## SUNDRY NOTICES AND REPORTS ON WELLS

XTO Energy Inc. intends to change this well from a vertically drilled well to a horizontally drilled well. XTO also proposes to change from a PC/FC well to Fruitland Coal only. Please see the attached revised C-102.

1 API Number		2 Pool Code		3 Pool Name	
4 Property Code		5 Property Name BOLACK B			6 Well Number 2R
7 GRID No.		8 Operator Name XTO ENERGY INC.			9 Elevation 6667

Bolack B #2R

**Plan: Sundry'd Wellbore (4-9-8)**

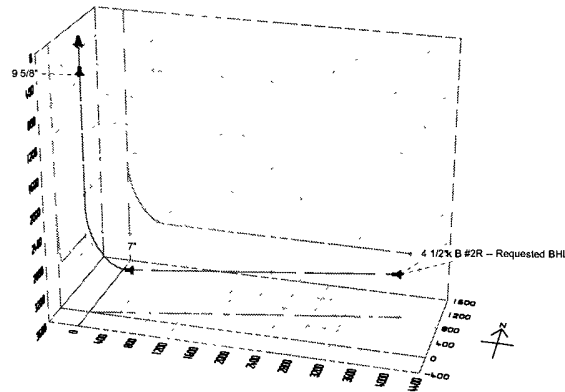
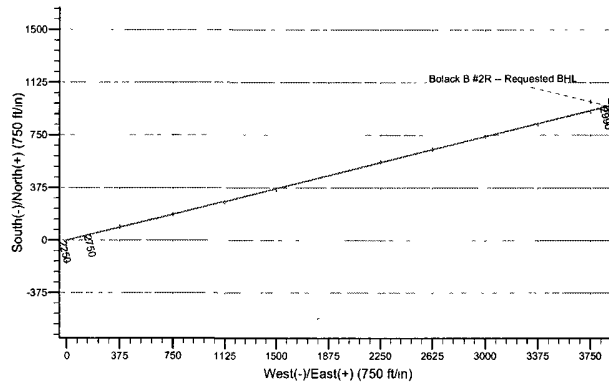
New BHL: 1900' FSL & 700' FEL

NOTIFY AZTEC OCD 24 HRS. CONDITIONS OF APPROVAL  
PRIOR TO CASING & CEMENT Adhere to previously issued stipulations.

Hold C104

for Directional Survey  
and "As Drilled" plat
